Clarifications and Follow-up Data Requests from Data Responses Set No. 4 and Emails

General Arrangement figure update and Site Plan for Howland Road Substation

HOWLAND ROAD GA SKETCH

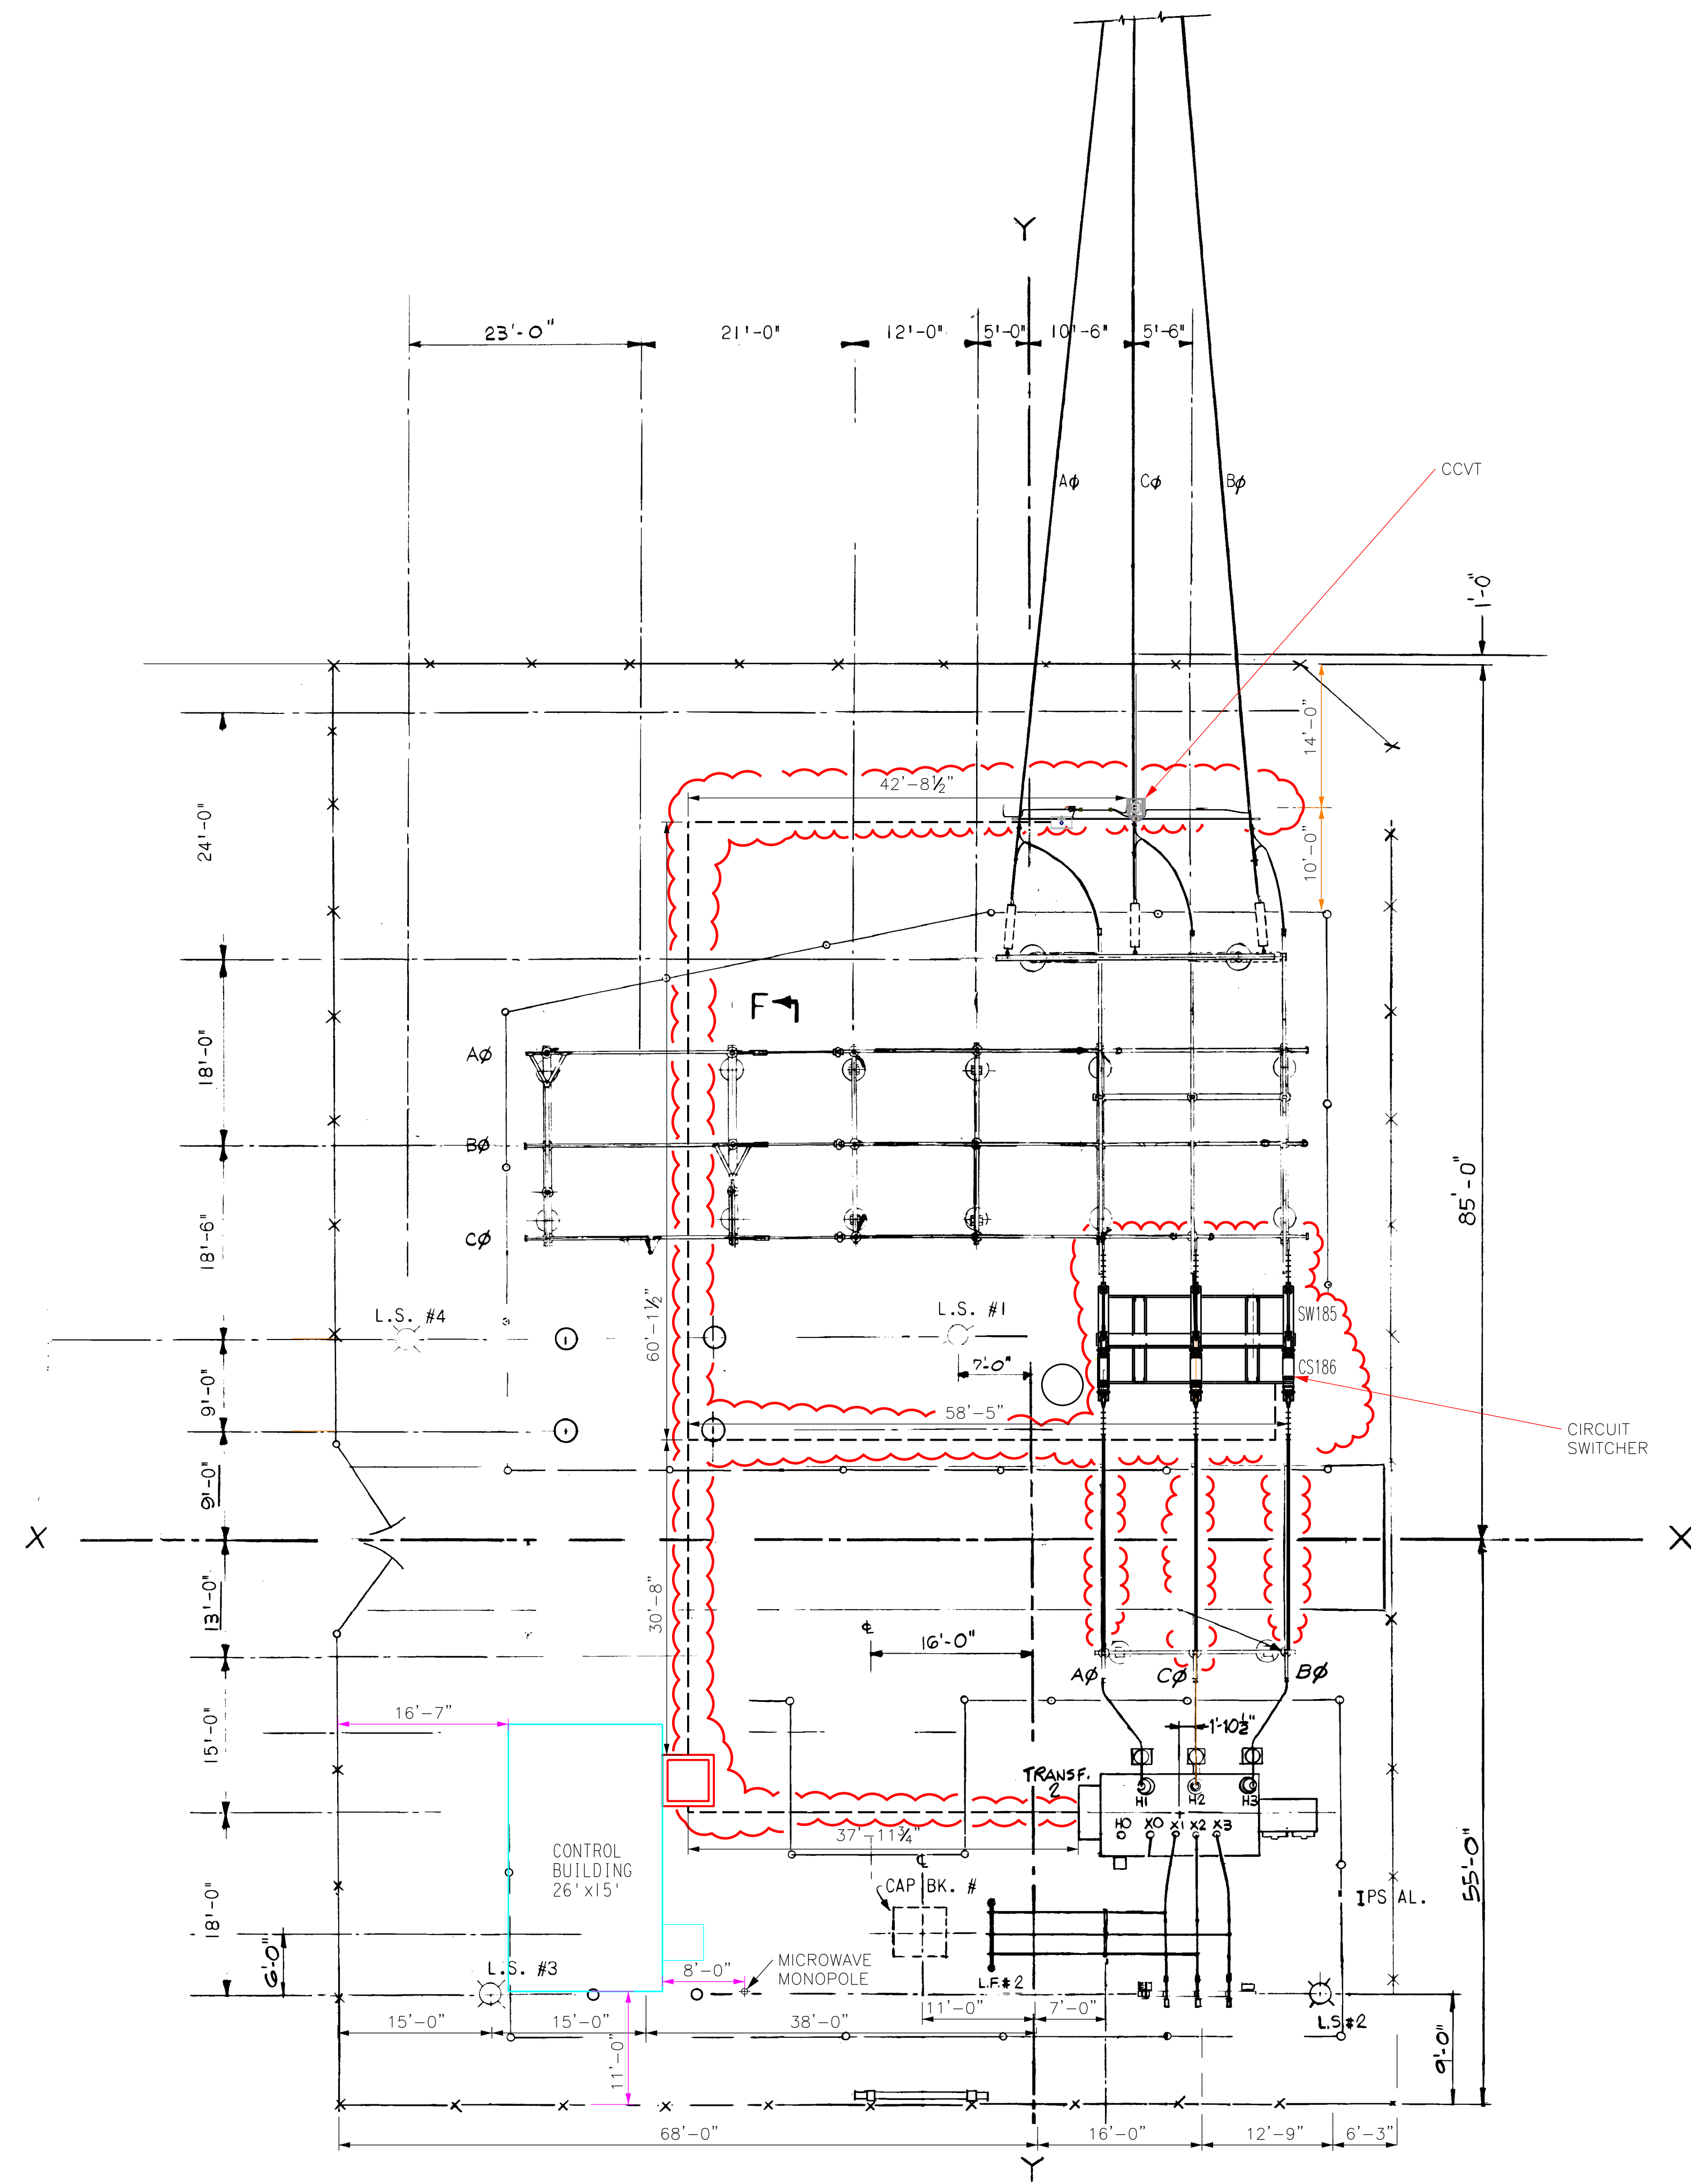
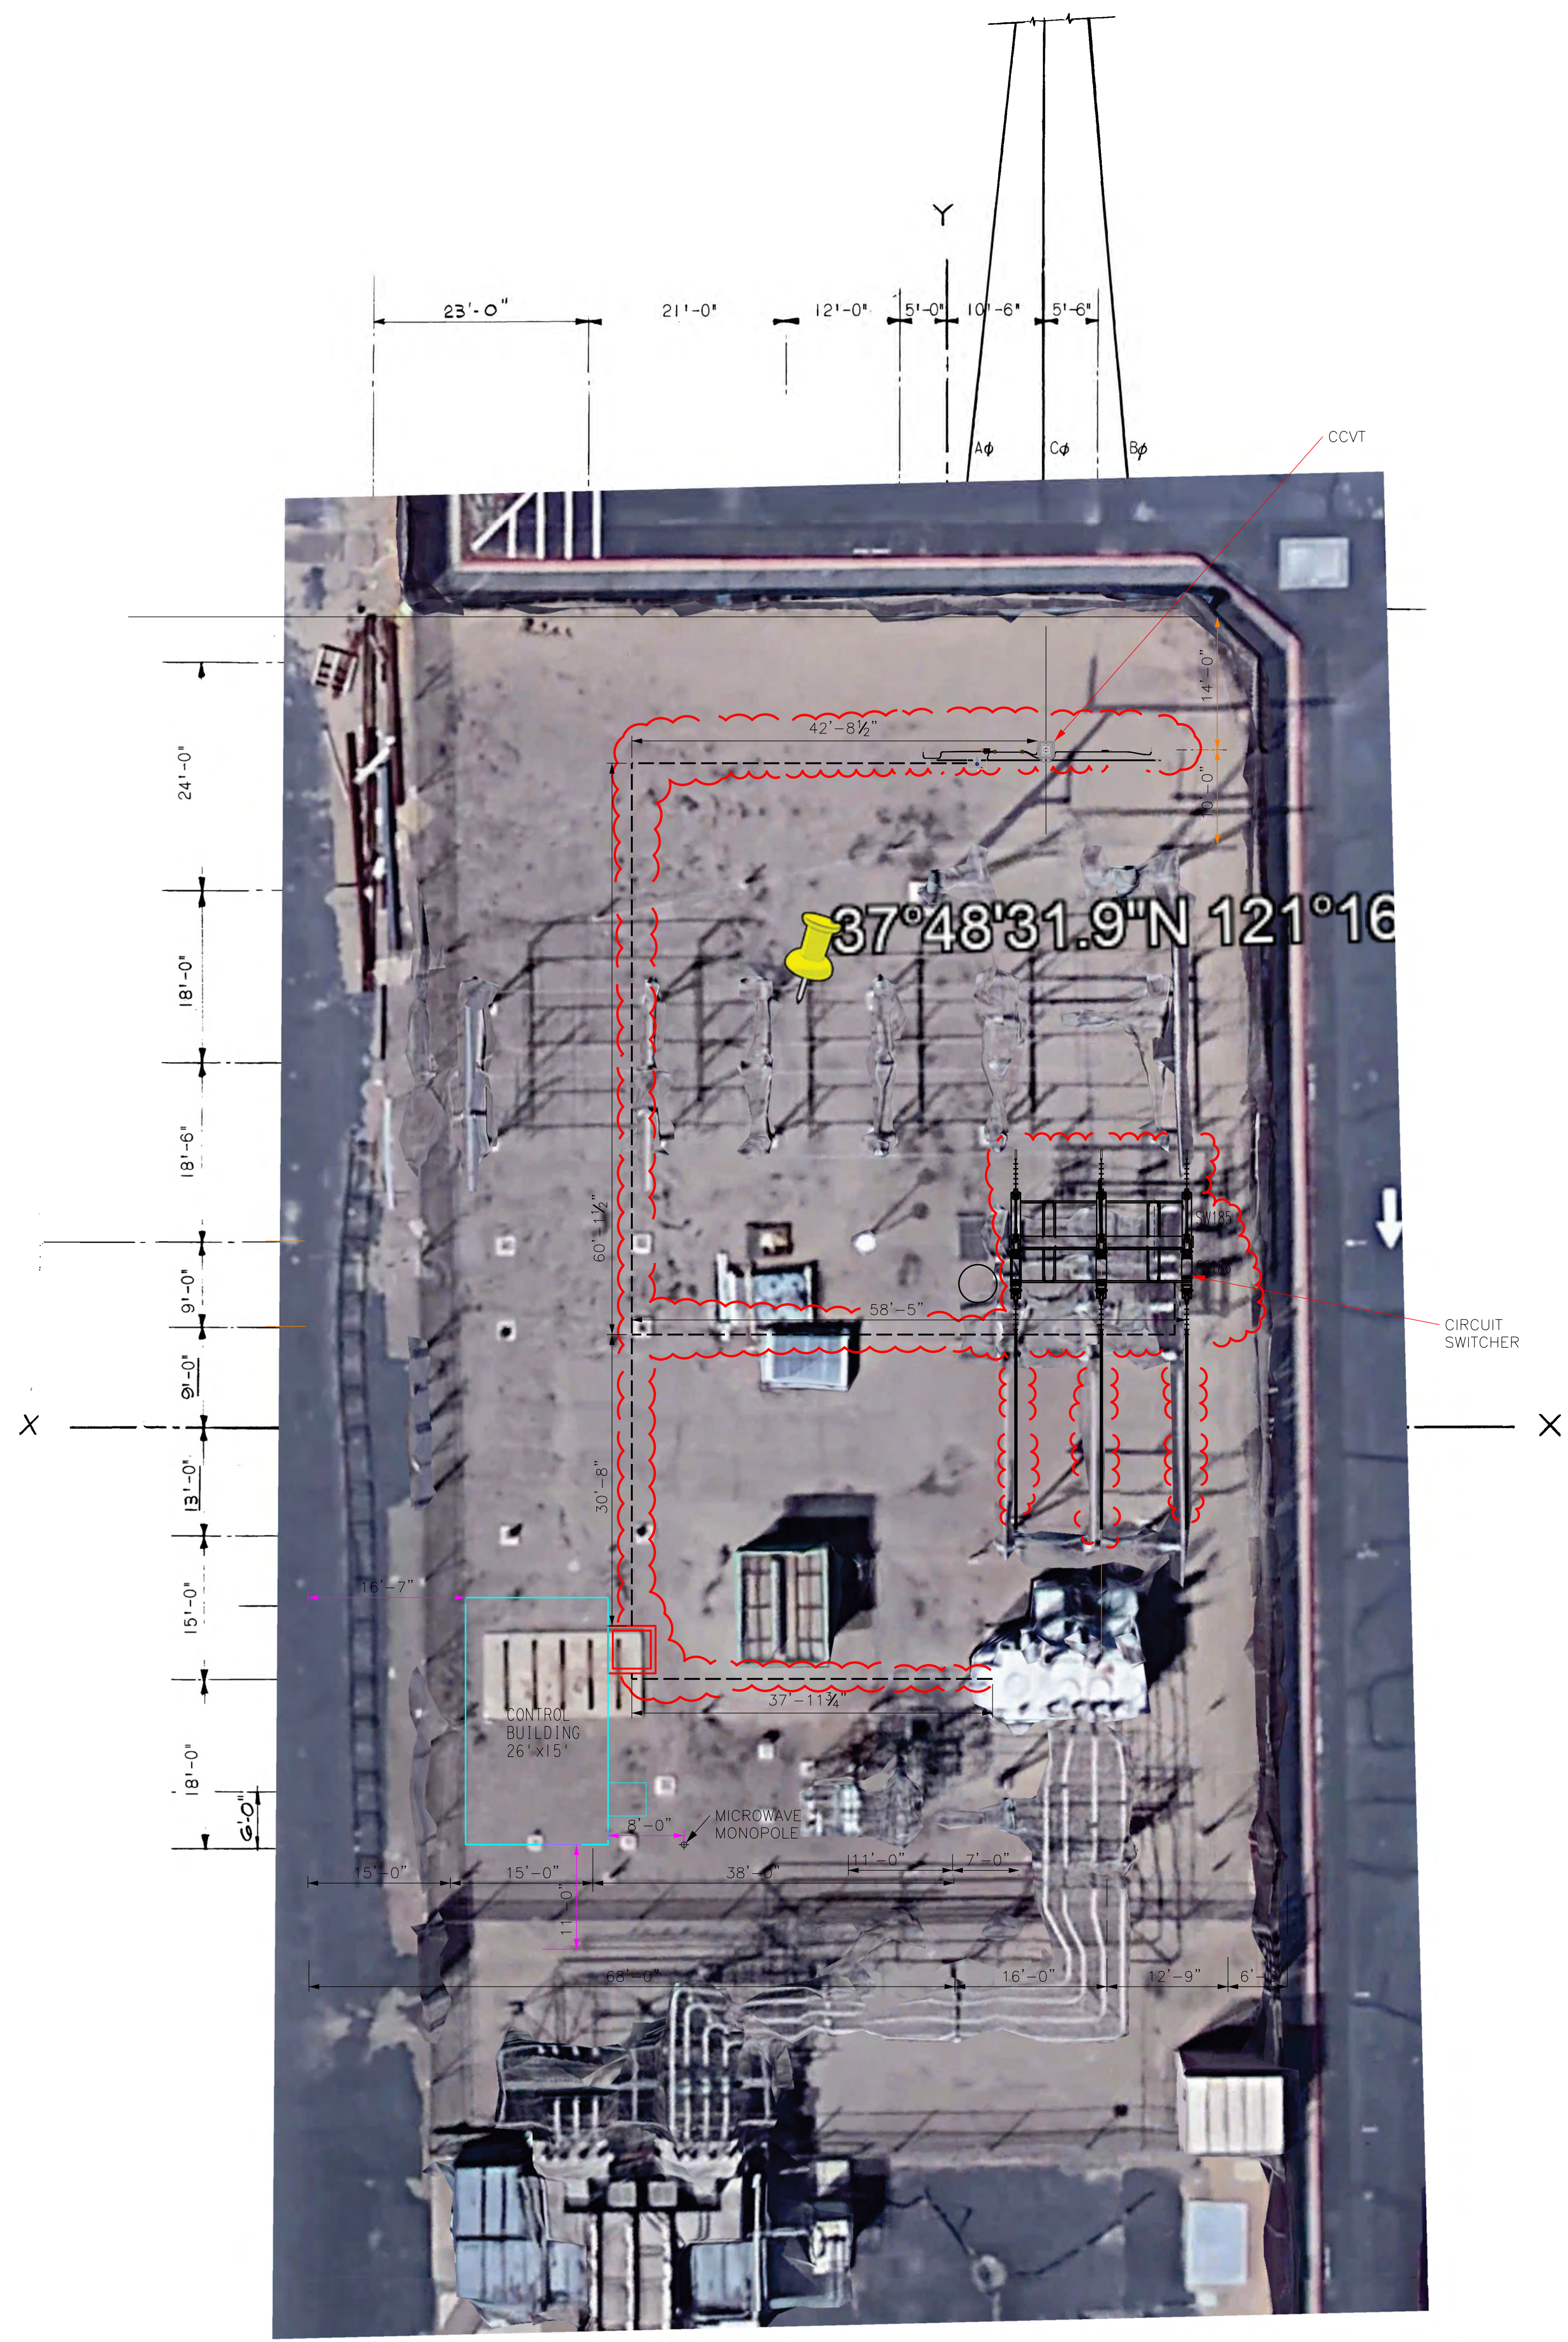
We believe this figure to be the as-built plans for the substation and assume the location of the proposed modifications are noted with the red wavy lines. We have the following requests:

1. We cannot confirm the length of the duct bank trench on the General Arrangement figure or confirm where the voltage transformer or its foundation would be located. There is no unit of measurement on the figure. See attached updated drawing.

2. It also appears that trenches will extend outside of the substation fence line along two routes. It appears that a combination of new trenching (within the fence line) and digging along a previously disturbed route to access existing trenching is proposed in the General Arrangement figure. Is this correct?

3. We also note that the control building dimensions on the figure don't match what appears to be the control building within the fence line of the substation. What appears to be the control building based on aerials is much smaller in size. We cannot find a building that meets the measurements shown on the figure. Please indicate where the existing control building is situated on-site.

4. We need the General Arrangement figure updated to show the location of the voltage transformer and its foundation, the location of the circuit switcher foundation, unit of measurements on the figure for the modifications (especially the trenching), and clearly mark the area to be trenched. Please provide a better legend that is more descriptive of the modifications and existing structures.

5. The General Arrangement figure doesn't seem to show how the substation relates to the surrounding environment. An aerial noting the location of proposed modifications will assist technical staff in their analysis and understand the nature of potential impacts. The General Arrangement figure does not provide context with the setting of the substation so an aerial is important. We also want to present this aerial in the environmental document to readers and decision-makers so they can visualize where the modifications would occur, and the surrounding environment in which they would be constructed.

Response: [The trench length is approximately 228 feet long.](#)

Response: [The trench is entirely within the substation boundary. See updated figure.](#)

Response: [The control building does not exist currently and is scheduled to be built prior to the Vierra Project.](#)

Response: [See attached.](#)

Response: [See attached.](#)
